Addendum No. 1 Receipt Certification

Project	Bathroom Renovation at the John C Hart Memorial Library		
Owner	Town of Yorktown, New York	Date	January 25, 2018

Addendum No. 1 - Receipt Certification

C BATHROOM No. 2 & 3 RENOVATION PLAN
 SCALE: 1/2" = 1'-0"

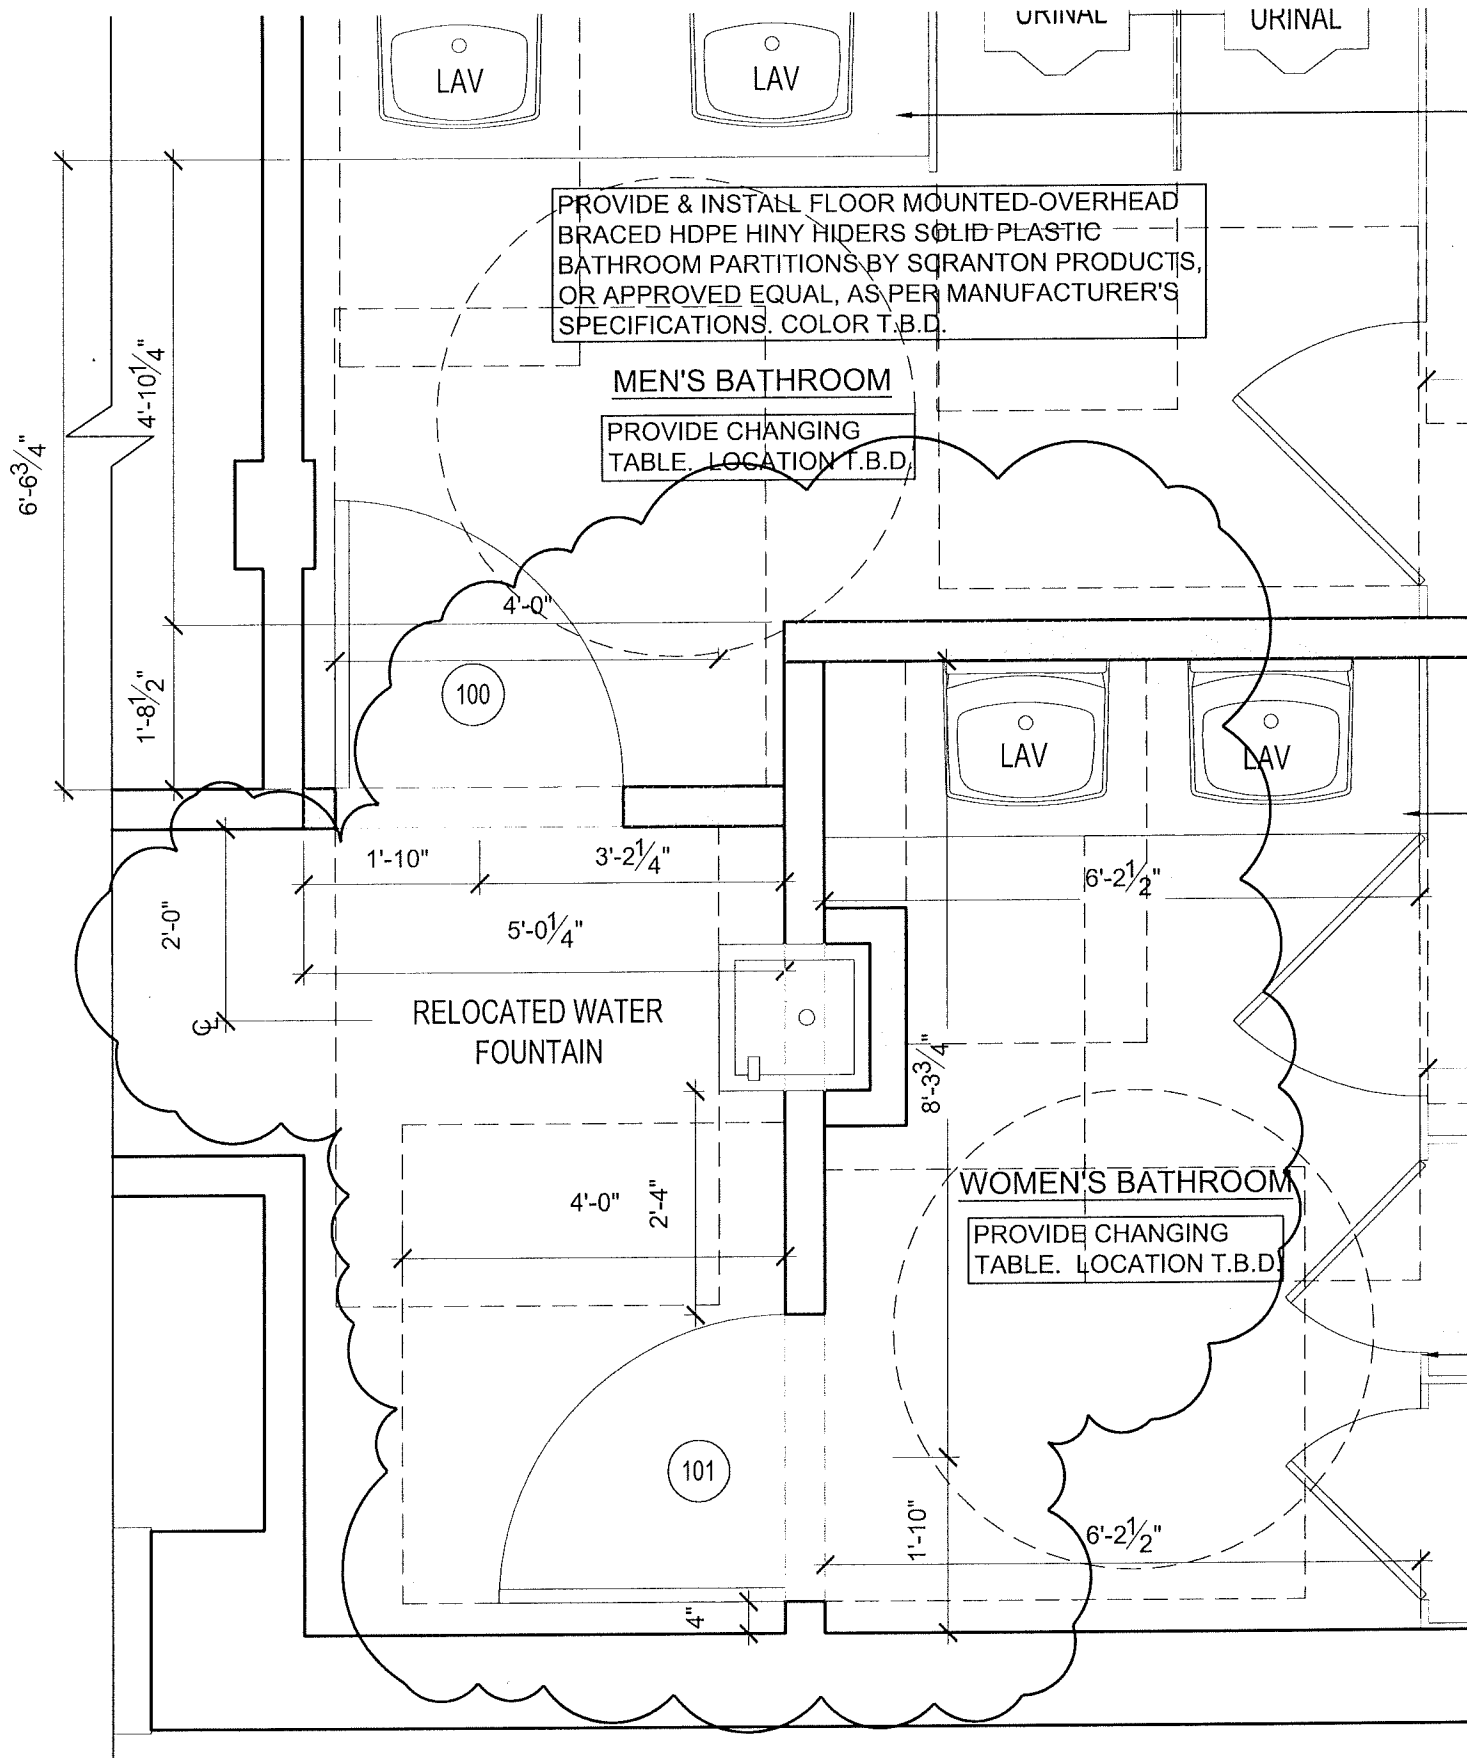
12. Clarification on the water fountain:
 - **RESPONSE: The existing water fountain is to be carefully removed and reinstalled as per sketch enclosed.**
